DRAINAGE LETTER

Woodmen Frontage Road Turn Lane

Bent Grass Meadows Drive & East Woodmen
Road

Drainage Letter_V3.pdf Markup Summary 5-17-2022

Drainage Map

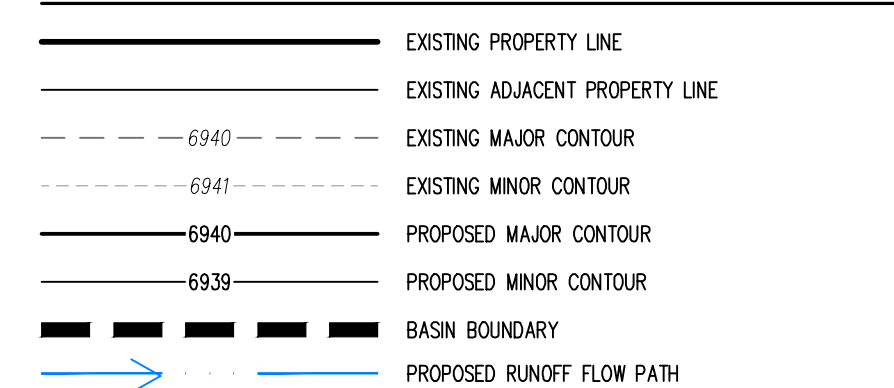
Update all basin labels to match hydrology spreadsheets & report

Label HP

Update all basin labels to match hydrology spreadsheets & report
